Service Bulletin No: 21-009

Modification No: EC-14-0379

**AIR CONDITIONING - DISTRIBUTION
INSPECT, AND IF NECESSARY, REPLACE THE AIR CONDITIONING HOSES IN THE DE-FOG SYSTEM****1. Planning Information****A. Effectivity**

Replacement of the ECS Hoses
Figure 1

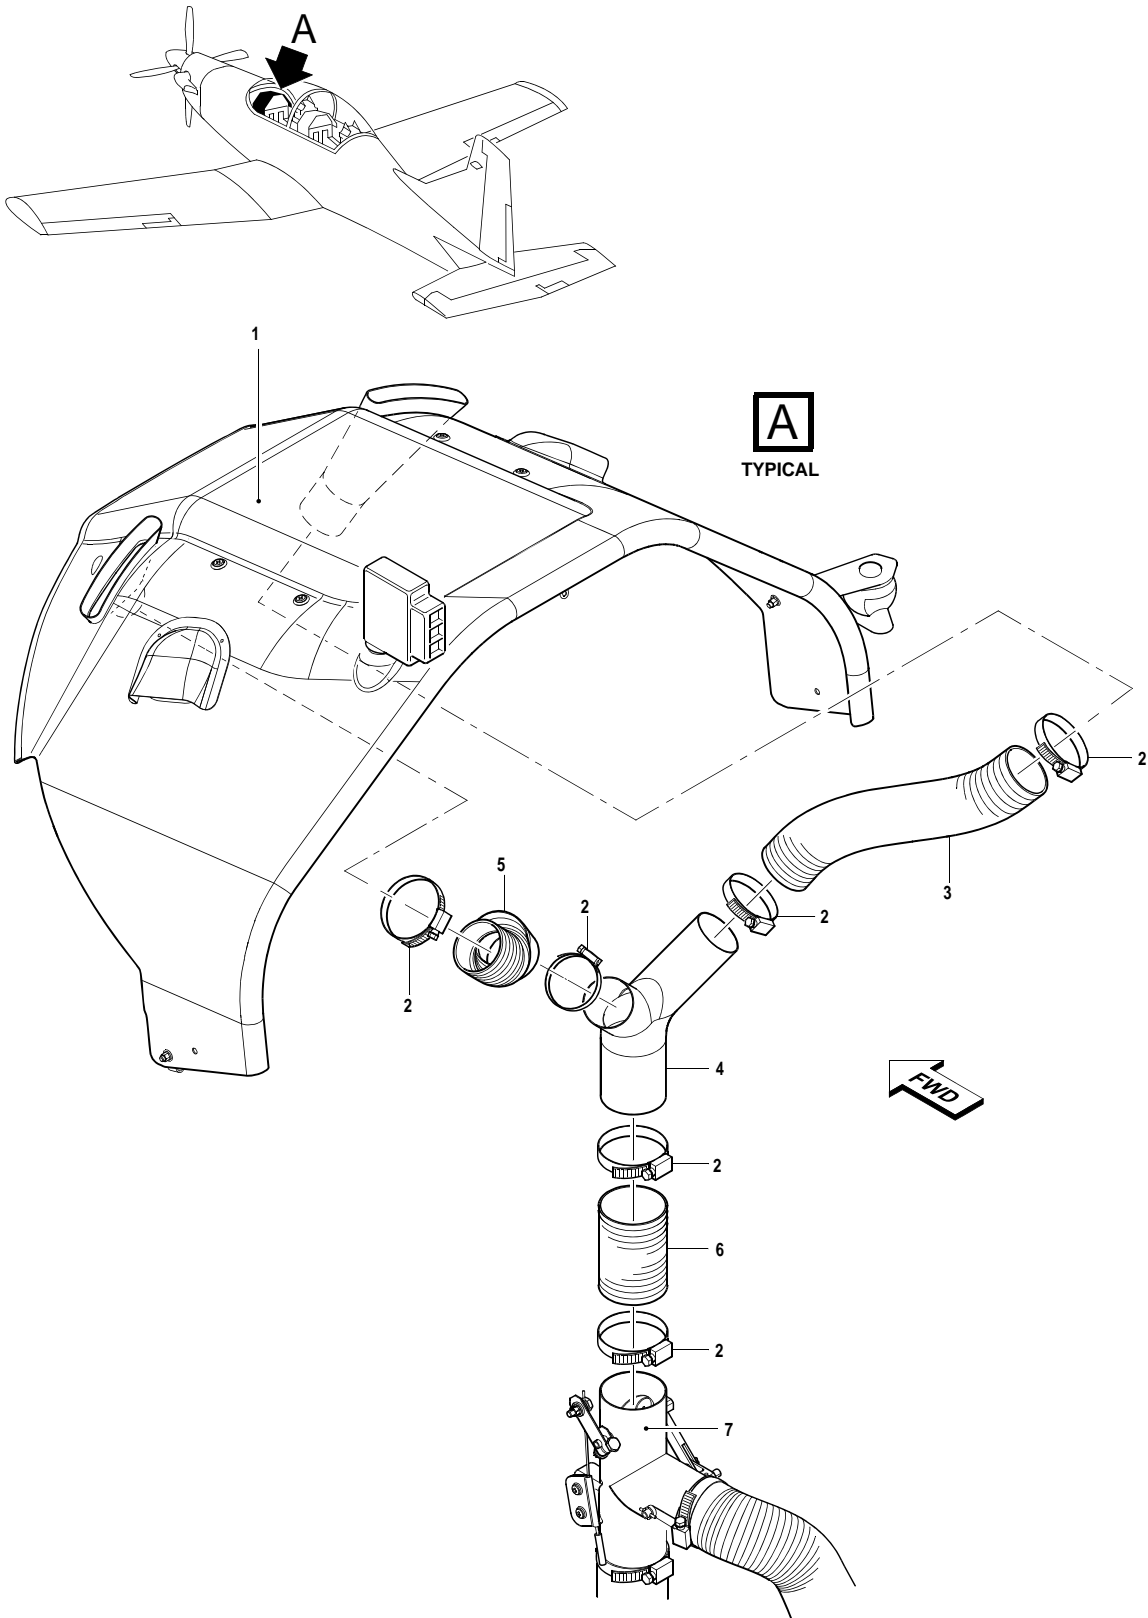
Some of the ECS air hoses have experienced delamination problems. This type of hose (type 984) was installed in new production and offered as replacement for in-service hoses. If a hose installed in the de-fog system collapses, it can impair the forward vision from the cockpit.

Do a one time inspection and replace all the type 984 hose installed in the de-fog system.

NOTE: The color of the type 984 hose is dark grey. The color of the other types of hoses (not affected by this Service Bulletin) is white.

- (1) Do an inspection of the ECS hoses, items (3), (5) and (6).
- (2) If the hoses are dark grey in color, they are type 984 and must be replaced.
- (3) Replace the ECS hoses:

- 1 Remove the front coaming (1) (Ref. AMM, 34-13-03, Page Block 401).
- 2 Loosen the clamps (2) that attach:
 - The air hose (3) to the air distributor (4)
 - The air hose (5) to the air distributor (4)
 - The air hose (6) to the air distributor (4) and the air distributor assembly (7).

- The new air hose (5) (P/N 917.96.83.051)
- The air hose (3) (P/N 917.96.83.052)
- The air hose (6) (P/N 917.96.83.054).

- The air hose (5) (P/N 917.96.83.051)
- The air hose (3) (P/N 917.96.83.052)
- The air hose (6) (P/N 917.96.83.054).

NOTE: Do not tighten the clamps (2) that attach the air hoses (3) and (5) to the front coaming (1). This is done during the front coaming installation (Ref. Step 3.B.(3)(b)4).
